Calvert Cliffs Nuclear Power Plant, Units 1 and 2
Renewed Facility Operating License Nos. DPR-53 and DPR-69
Docket Nos. 50-317 and 50-318

Subject: Supplement to Response to Request for Additional Information Regarding the Spent Fuel Pool Cooling - Shutdown Cooling Systems Licensing Design Basis License Amendment Request

Supplement to the RAI Response for the Spent Fuel Pool Liner Stresses

Timoshenko "Theory of Elastic Stability, 2nd Edition, Figure 2-36 (Page 91)

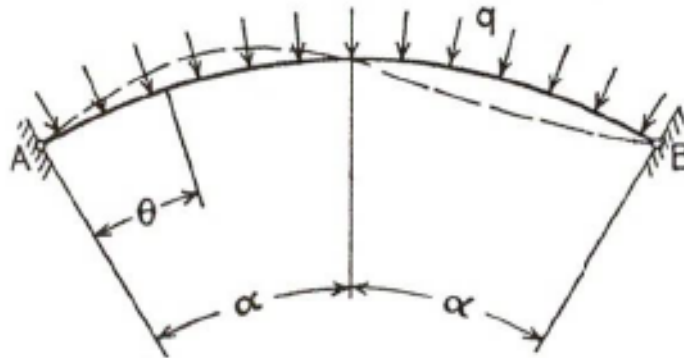
“Describe, with quantitative results, how the structural acceptance criteria were met for the SFP walls and its liner for the controlling load combinations including thermal loads.”

The overall approach is that as the temperature in the SFP rises above the temperature associated with a zero-stress condition, the differential coefficients of thermal expansion of the stainless steel liner and underlying concrete cause them to expand at different rates. The differential is significant: 9.5×10^{-6} in/in/°F for stainless steel (Ref. B31.7-1969), and 5.5×10^{-6} in/in/°F for concrete (Ref. "Reinforced Concrete Designer's Handbook," 10th Edition, by Reynolds and Steedman). Since the two are connected together at regularly spaced attachment points, and the coefficient of thermal expansion for stainless steel is the higher of the two, the concrete will act to constrain thermal growth of the liner. The result is axial compressive stress in the liner that causes it to buckle in the manner shown below, where P is the axial load due to differential thermal expansion and l is the distance between attachment points to the concrete.

Above the waterline or at shallow depths where the hydrostatic pressure is low, the buckled shape shown above can form quite easily. However, as depth increases, the hydrostatic pressure counters the lateral deflection.
